**PROBLEM:**

There have been some complaints from the field about engine vibration on the H1, especially when the machine is operated at high speeds.

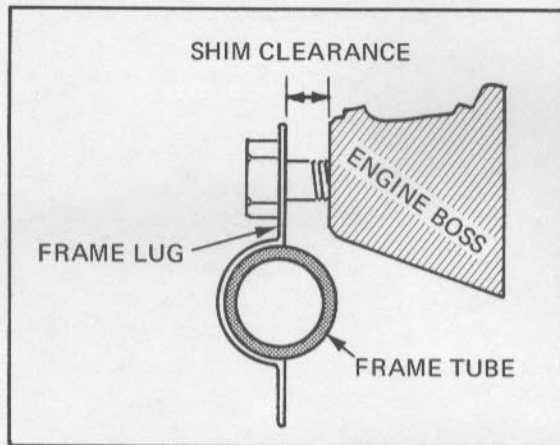
- A. Take off the left and right mufflers and enter exhaust pipe holder nuts. **IMPORTANT:** This step relieves the front mounting lugs of outside stresses which could affect shim adjustment. Loosen the engine mount bolts shown.

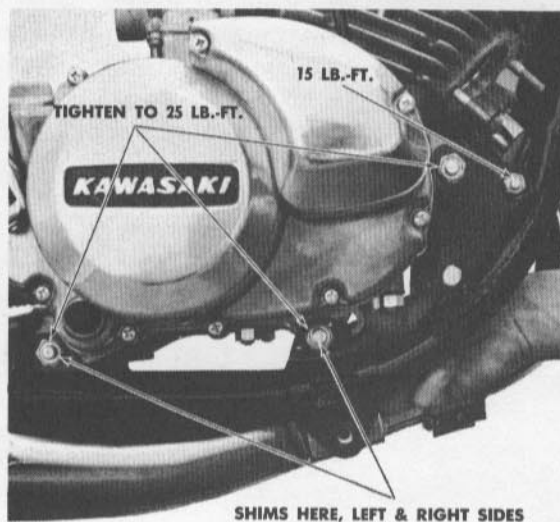
- B. Without removing the engine, use a thickness gauge to check the clearances between the engine bosses and the frame lugs on both sides of the machine as shown.

- C. At each of the four gaps, insert the proper size shim to take up all clearance. **NOTE:** If necessary, the shims can be stacked to get the right thickness.
- D. Tighten the three 10mm diameter engine mounting bolts to 25 lb.-ft. torque. Then tighten the 8mm diameter bolt to 15 lb.-ft.
